Notice of Intent

Type of Action: Variance

**Procedure Description:** Mewbourne requests a variance to perform break testing and offline cementing per attached procedures for the following wells: ZACH 8 W0OB FED COM 1H APD ID# 104000088278 ZACH 8 W0PA FED COM 1H API# 3002551710 ZACH 8 W1OB FED COM 1H API# 3002551711 ZACH 8 W1PA FED COM 1H APD ID# 10400088571 ZACH 8 W2OB FED COM 1H API# 3002551714 ZACH 8 W2PA FED COM 1H API# 3002551715 ZACH 8 W2PA FED COM 2H API# 3002551716

## PECOS DISTRICT DRILLING CONDITIONS OF APPROVAL

Figure 1. BOP diagram

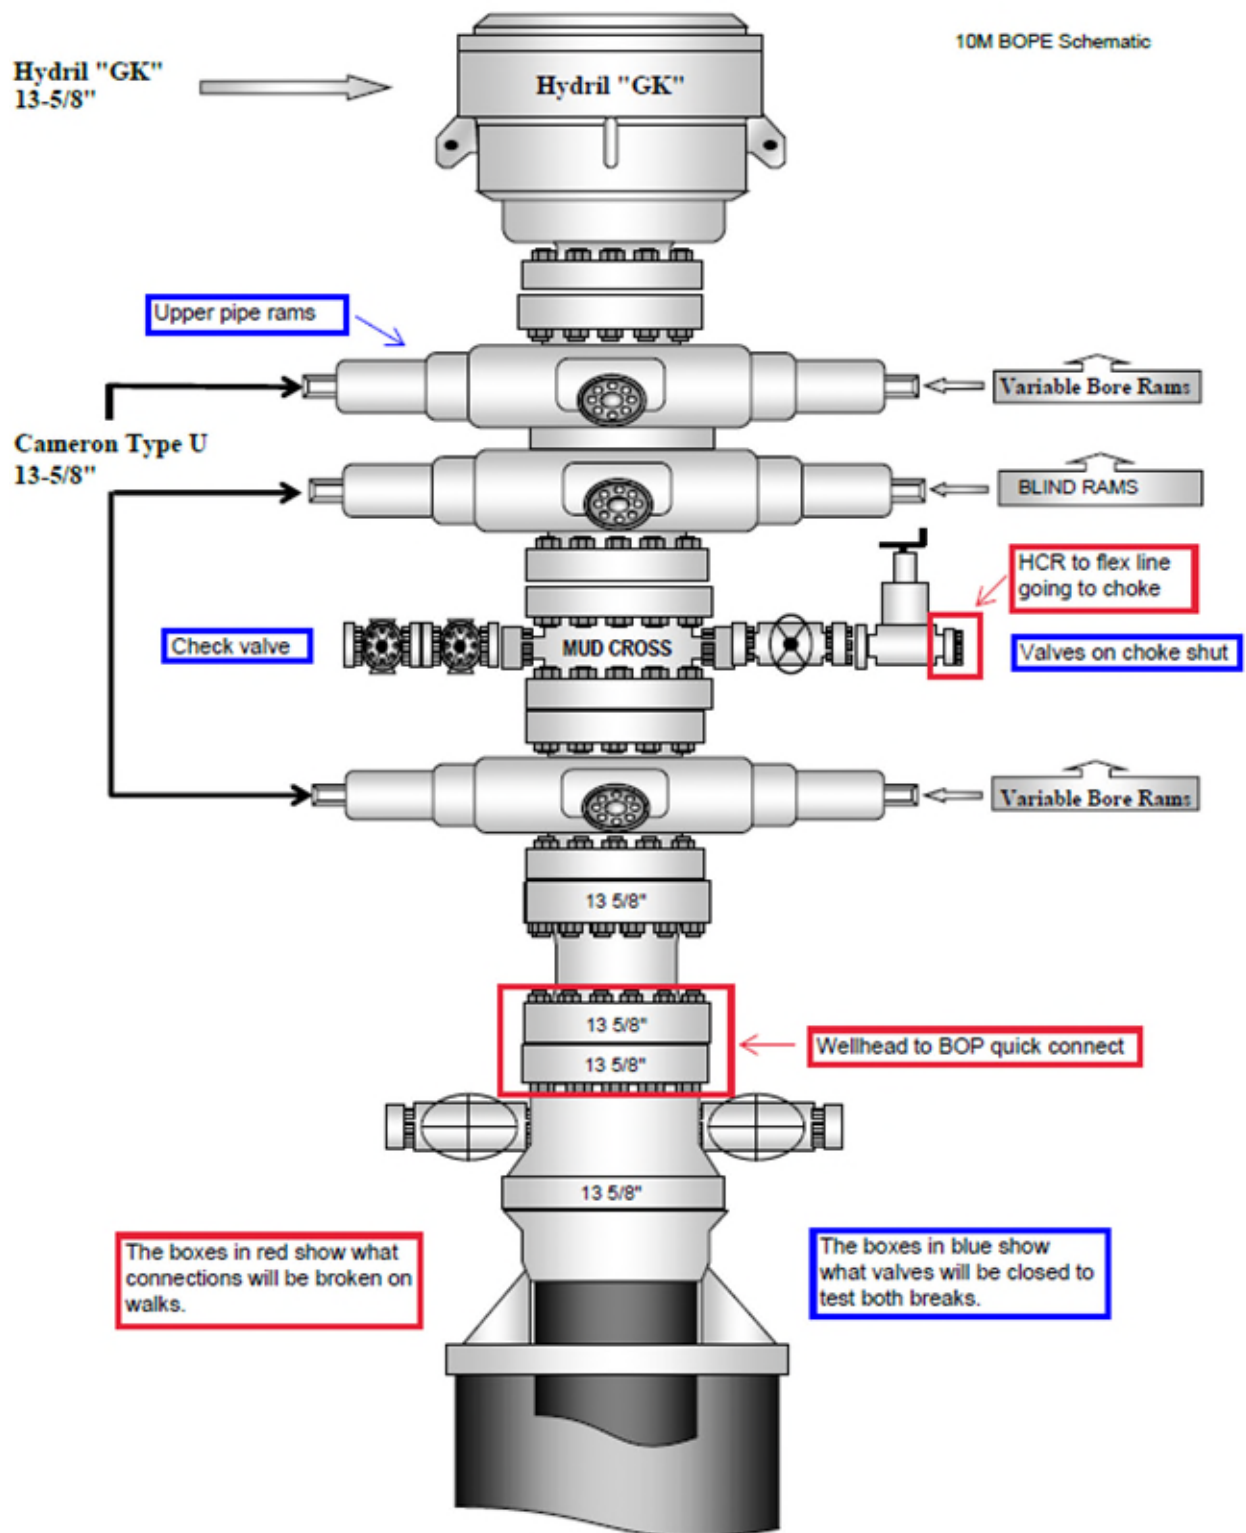
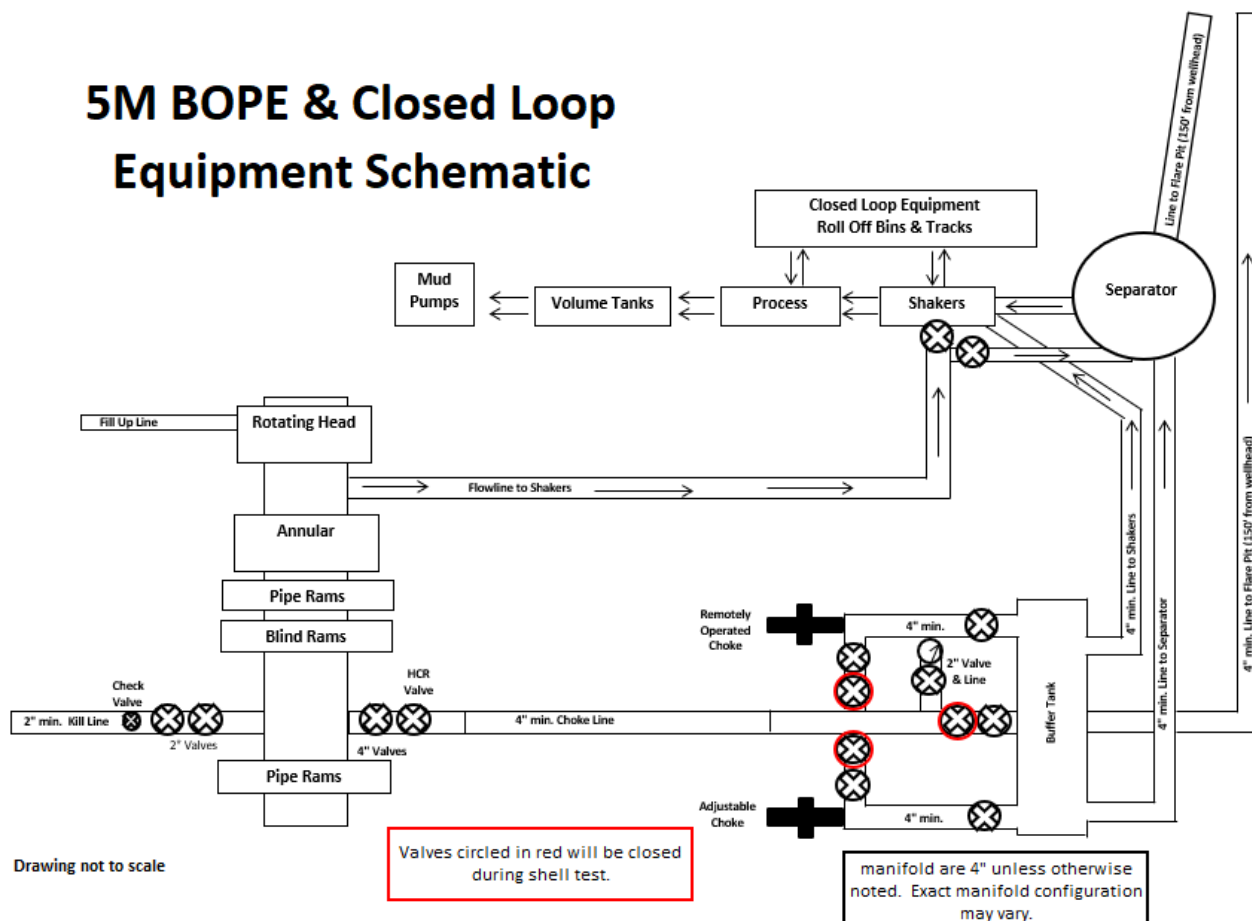
2. After the well section is secured and the well is confirmed to be static, the BOP will be disconnected from the wellhead and walked with the rig to another well on the pad. Two breaks on the BOPE will be made (Fig. 1).

9. A test will then be conducted against the upper pipe rams and choke, testing both breaks (Fig. 1 & 2).
10. The test will be held at 250 psi low and to the high value submitted in the APD, not to exceed 5000 psi.

- BOPE Break Testing is ONLY permitted for intervals utilizing a 5M BOPE or less. (Annular preventer must be tested to a minimum of 70% of BOPE working pressure and shall be higher than the MASP.)

- While in transfer between wells, the BOPE shall be secured by the hydraulic carrier or cradle.
- Any well control event while drilling require notification to the BLM Petroleum Engineer (575-706-2779) prior to the commencement of any BOPE Break Testing operations.

- A full BOPE test is required prior to drilling the first deep intermediate hole section. If any subsequent hole interval is deeper than the first, a full BOPE test will be required. (200' TVD tolerance between intermediate shoes is allowable).

Figure 3. BOP handling system

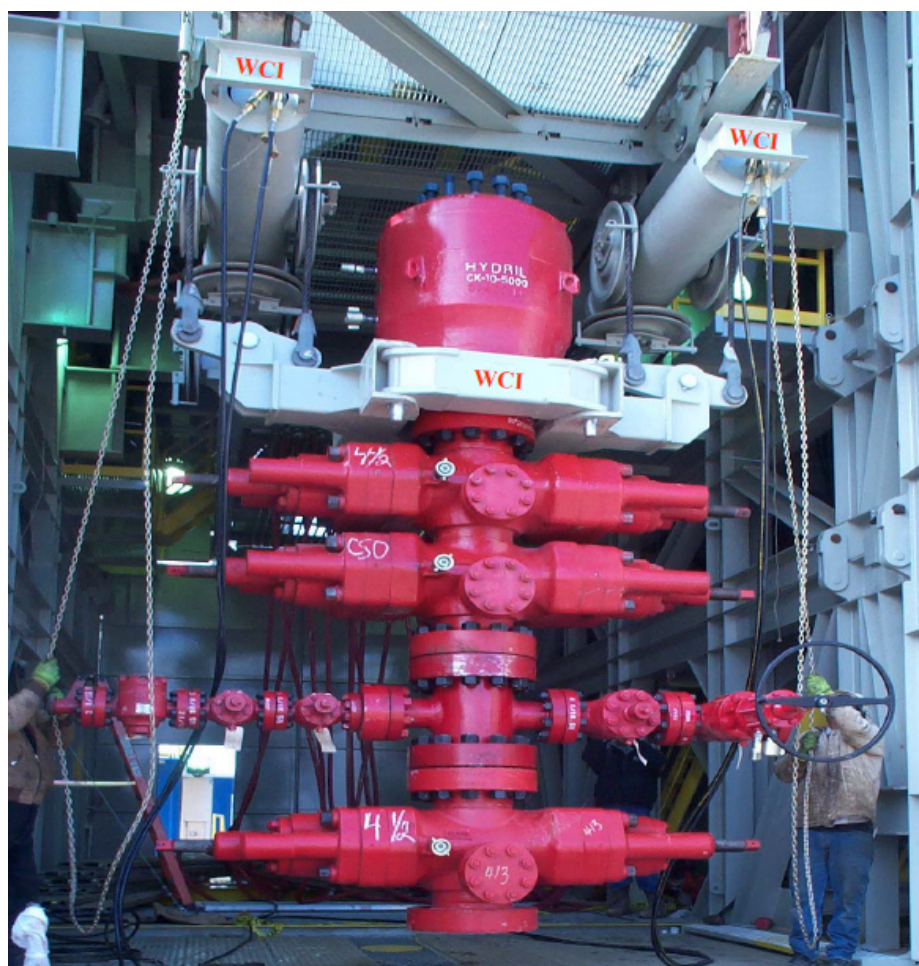
4. The BOP will be removed and carried by a hydraulic carrier (Fig. 3 & 4).
5. The rig will then walk to the next well.
6. Confirm that the well is static and remove the capping flange.
